AMENDMENT CHANGES

ISSUE/REVISION	DATE	NO.
GDP AMENDMENT	5/2/2025

AVISTA ADVENTIST
HOSPITAL

GENERAL
DEVELOPMENT PLAN
AMENDMENT NO. 2

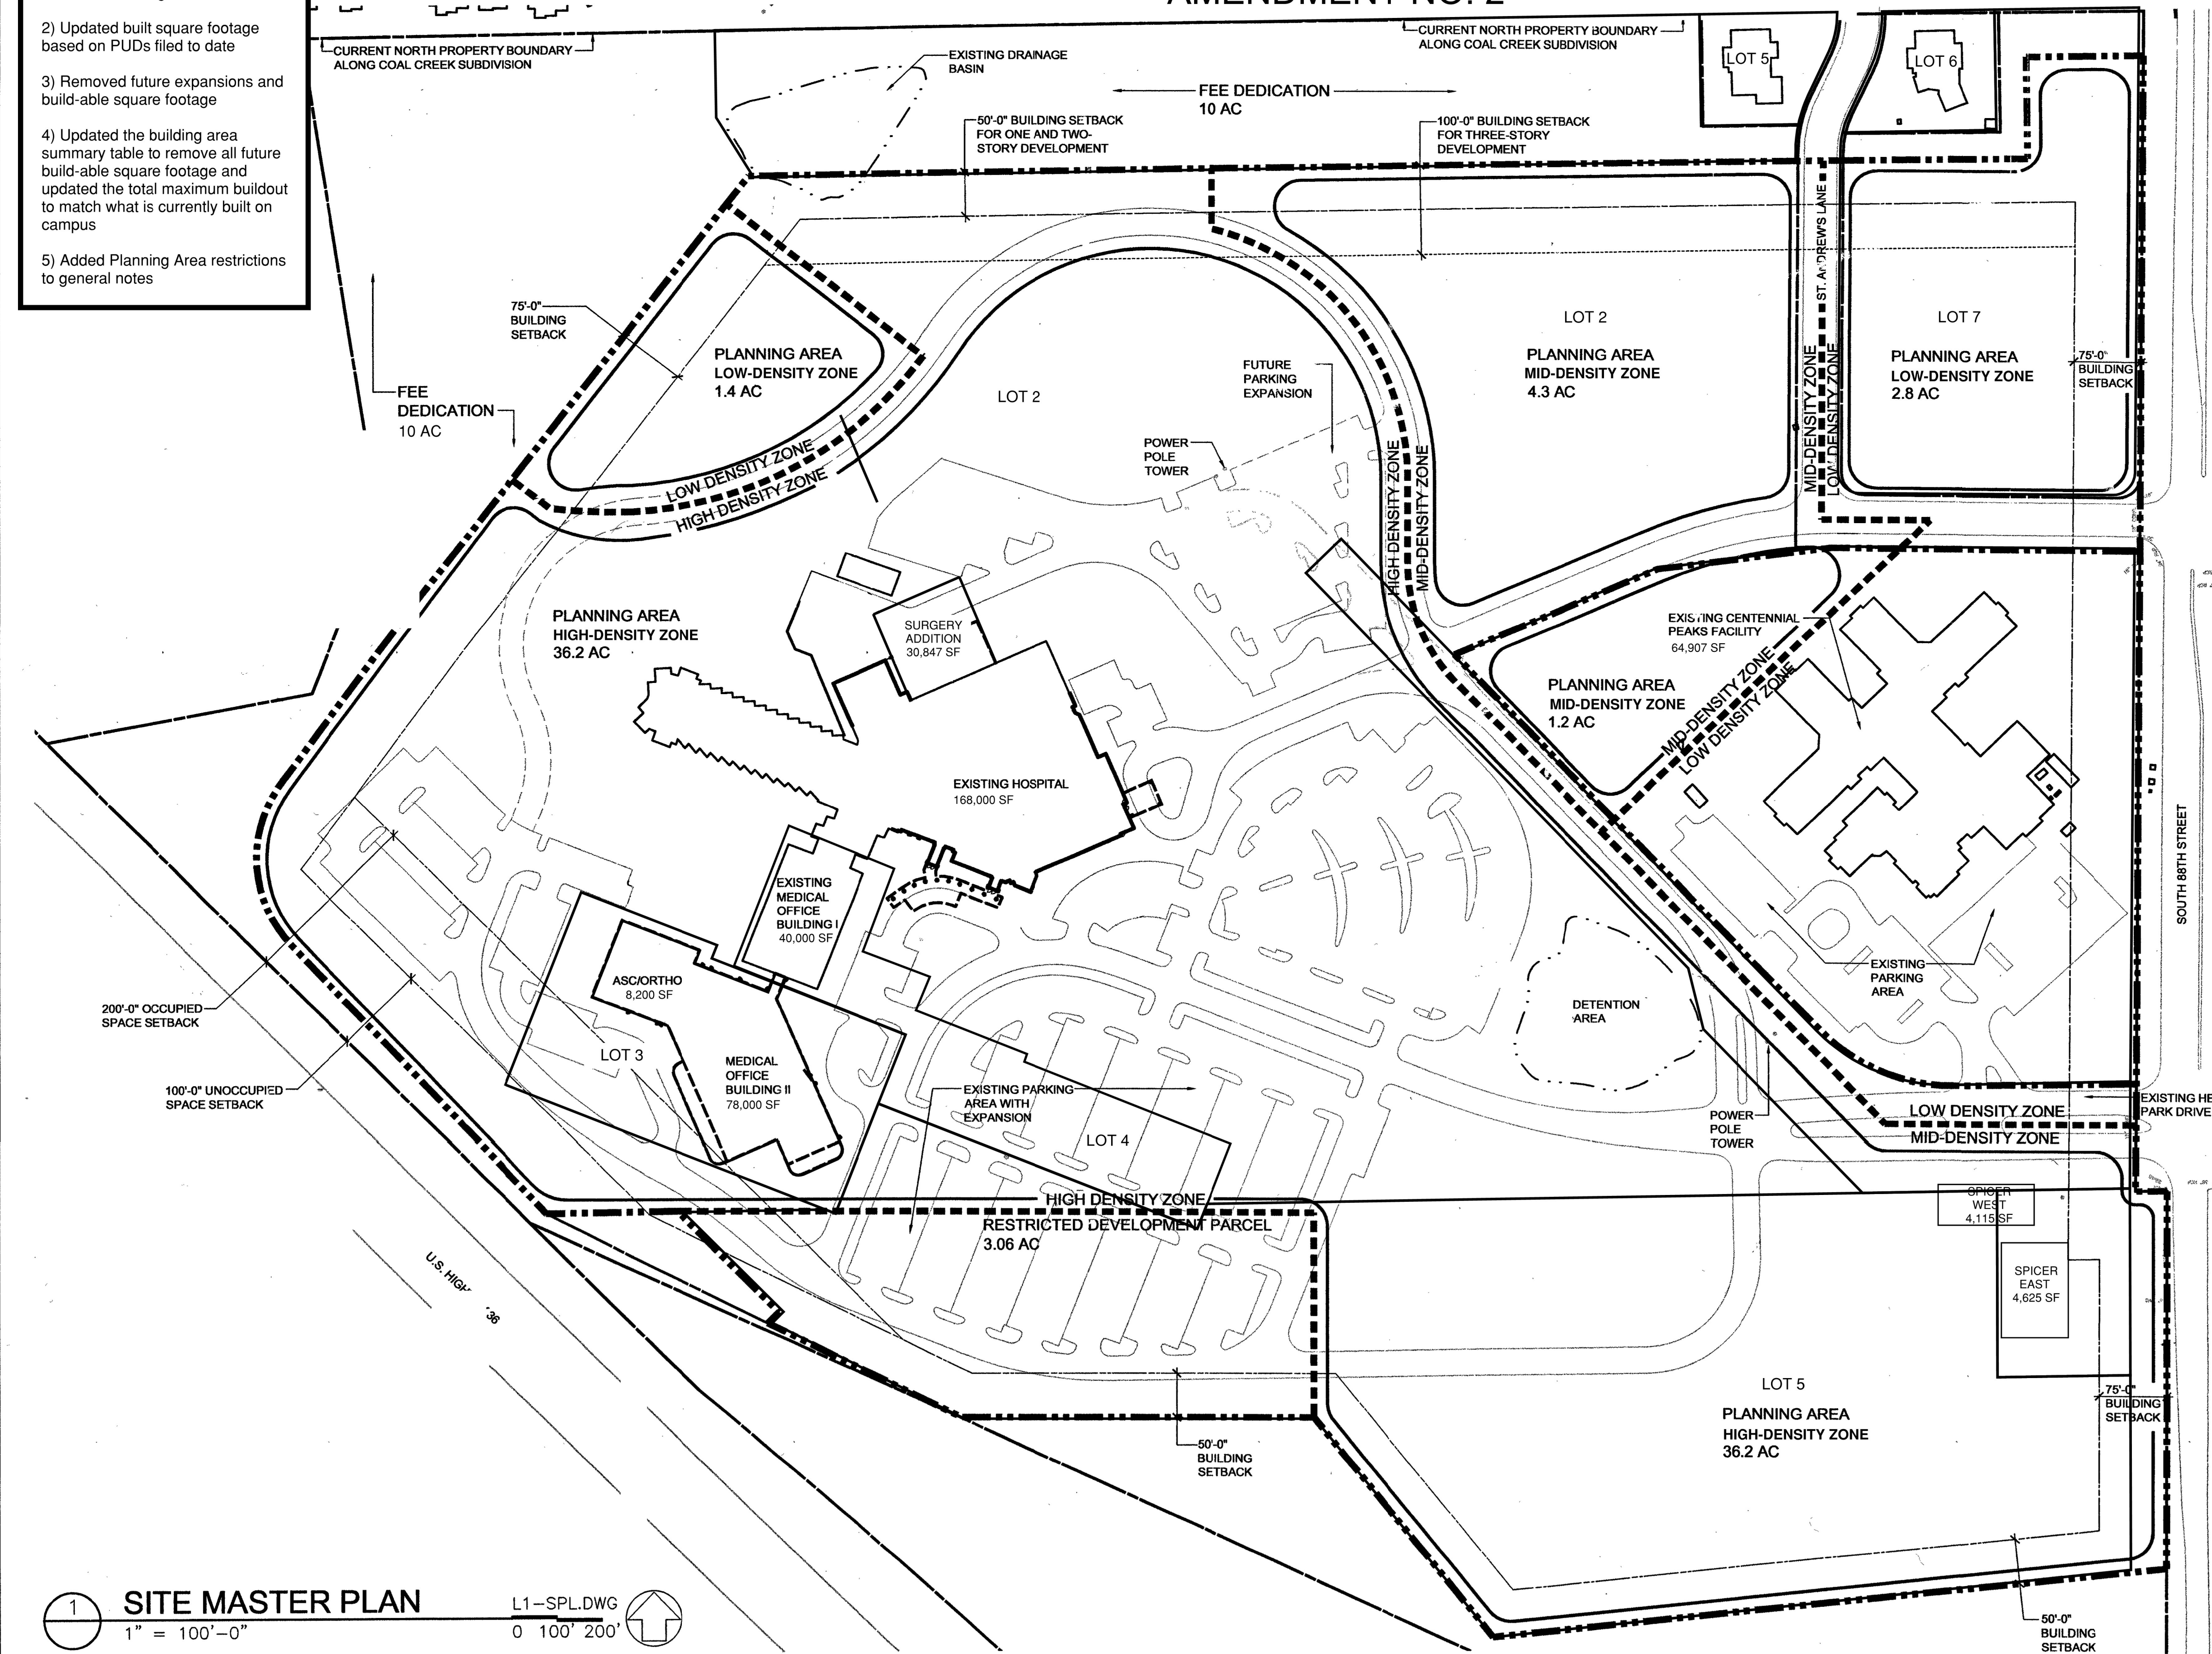
- 1) Updated planning areas to better align with the platted boundaries based on the Health Park Subdivision Filling 6 Final Plat
- 2) Updated built square footage based on PUDs filed to date
- 3) Removed future expansions and build-able square footage
- 4) Updated the building area summary table to remove all future build-able square footage and updated the total maximum buildout to match what is currently built on campus
- 5) Added Planning Area restrictions to general notes
